**SV CSG PLATO 1, LLC (SUNVEST)
05-15-300-024**

**JOHN GILMORE
12-12-153-003, 12-12-153-006
33W835 AND 33W859 CHERRY LANE, GENEVA 60134**

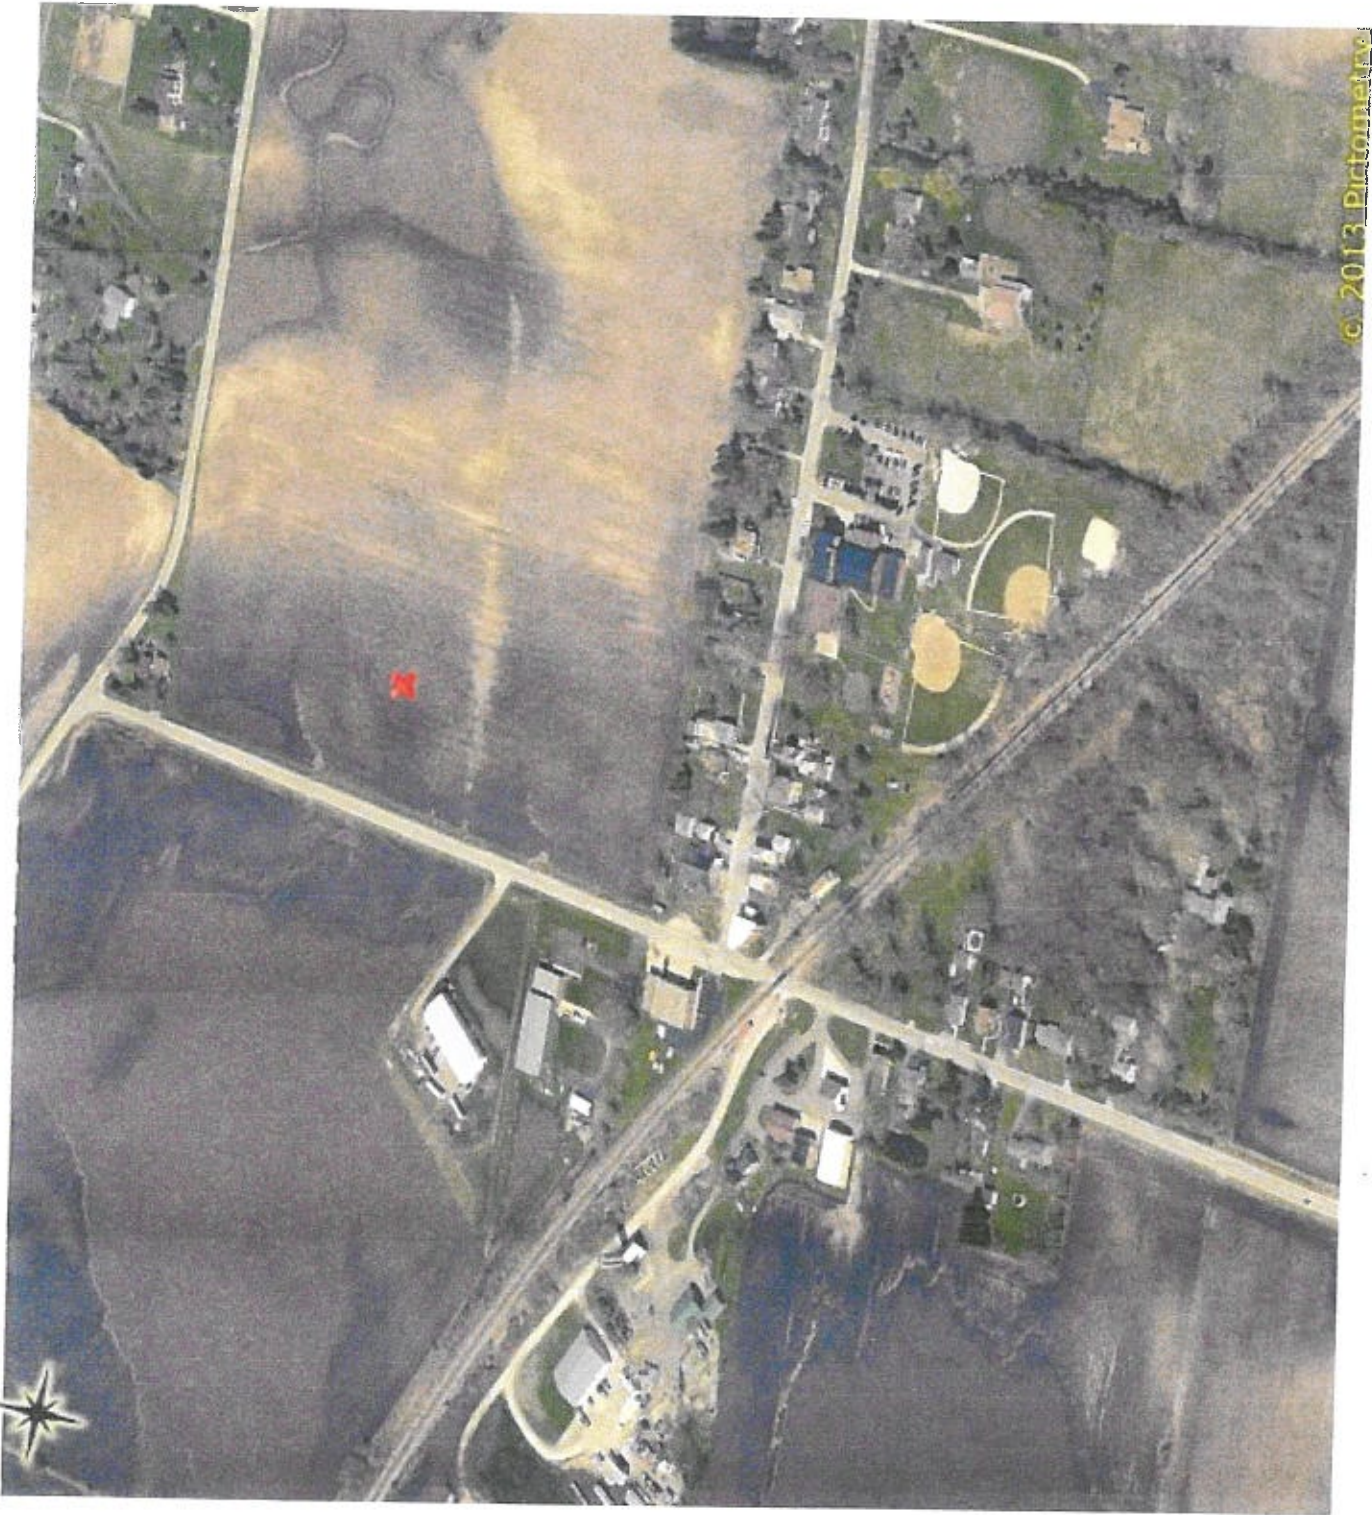
Water Resources will require a stormwater permit for this development. An Engineer's report will be required as part of this permitting. If the peak flow for the site with the proposed development is increased, stormwater detention will be required for the development.

Water Resources has a history of drainage issues in this area. Water Resources is looking for the protection of the tile system that is in place, including replacement in kind for the aged 10" concrete pipe (that runs east-west) that serves as conveyance with impacts on both the upstream and downstream properties. In order to fully understand the conveyance of this system, Water Resources will be requiring further study of the upstream and downstream connections and flow capacity of this system.

In addition as part of this protection, observation structures should be installed and all lines connected into this pipe preserved and repaired as needed. There is a drainage issue to the north and south of the property that impacts the property owners. Water Resources is recommended as part of this development a drain tile be installed running from the far north east corner of the property and along the south property line in the setback into the 10" conveyance pipe (that runs east-west), to relieve these areas of flooding issues.

Water Resources is also recommending plantings within the development which will not interfere with drain tiles. Many of the native low growing plantings have long root systems that can interfere with tile systems and cause off site issues including surcharged drain tiles and blow outs of the drain tile systems. Any plantings would need to be approved in the stormwater. Water Resources would recommend the condition of 80% vegetative coverage for plantings be a requirement for the site.
